Project	<b>IEEE 802.16 Broadband Wireless Access Working Group</b> < <a href="http://ieee802.org/16">http://ieee802.org/16</a> >	
Title	<b>MRS Paging Group Update</b>	
Date Submitted	<b>2007-01-08</b>	
Source(s)	Shashikant Maheshwari, Yousuf Saifullah, Haihong Zheng Nokia 6000 Connection Drive, Irving, TX	Voice: 972 839 1878 Fax: <a href="mailto:shashikant.maheshwari@nokia.com">shashikant.maheshwari@nokia.com</a> , <a href="mailto:Yousuf.saifullah@nokia.com">Yousuf.saifullah@nokia.com</a> , <a href="mailto:haihong.1.zheng@nokia.com">haihong.1.zheng@nokia.com</a>
Re:	This is in response to the call for proposal, 80216j-07_034.pdf, sent out by 802.16j TG.	
Abstract	This contribution proposes MRS Paging Group Update procedure that would support MS location update very efficiently.	
Purpose	Add proposed spec changes.	
Notice	This document has been prepared to assist IEEE 802.16. It is offered as a basis for discussion and is not binding on the contributing individual(s) or organization(s). The material in this document is subject to change in form and content after further study. The contributor(s) reserve(s) the right to add, amend or withdraw material contained herein.

# MRS Paging

Figure 2: Message sequence for the proposed MRS Paging Group Update process

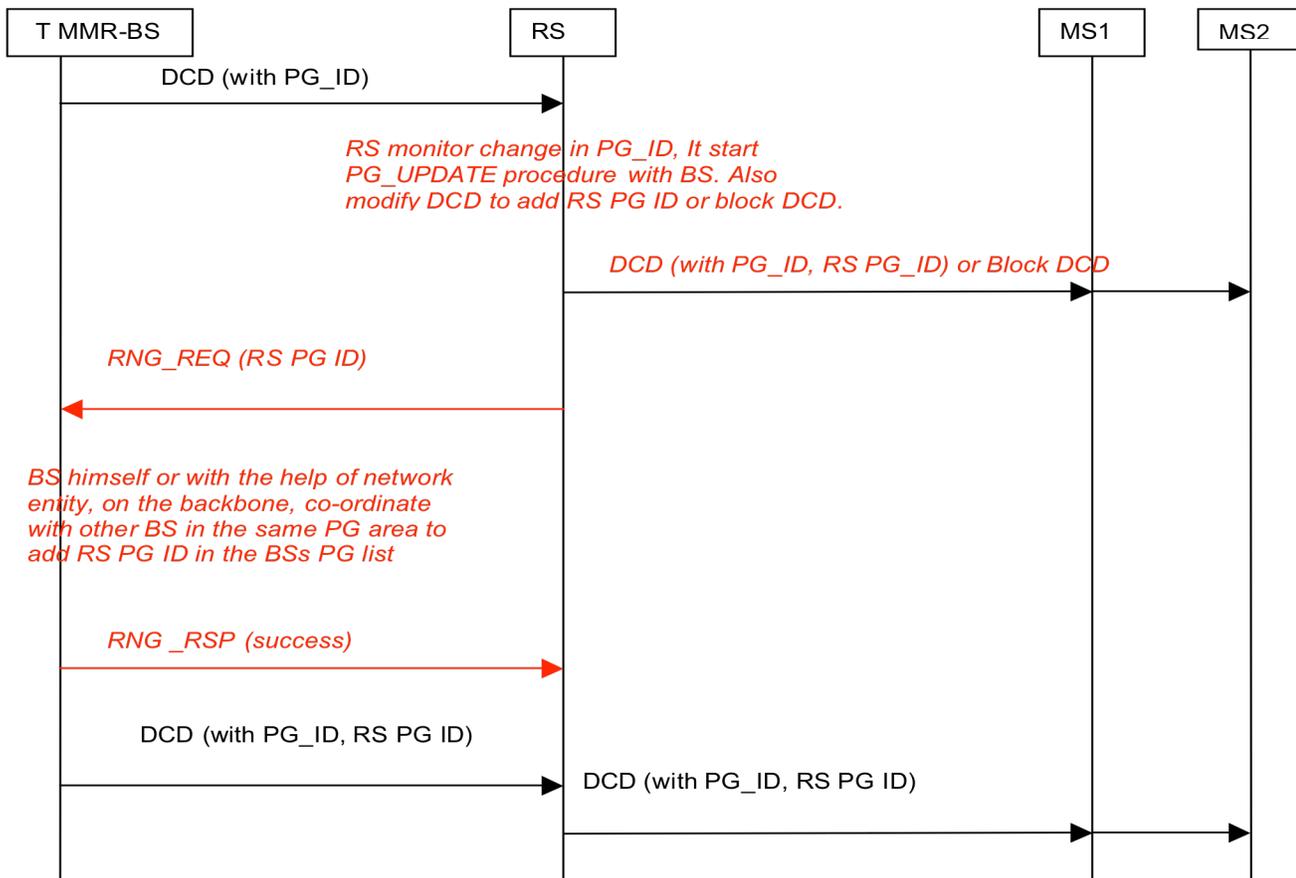
While above procedure between MRS and MMR-BS is ongoing, Depending upon the MRS capability, it will either keep modifying DCD and/or MOB\_PAG\_ADV messages by adding its own PG\_ID in the PG\_ID list or block the transmission of DCD and MOB\_PAG\_ADV message. When MRS receives RNG\_RSP, it will stop modifying or blocking these broadcast messages. Figure 2 describes the message interaction between MMR-BS, MRS and sub-ordinate MSs. Modifications are shown in **RED italic**.
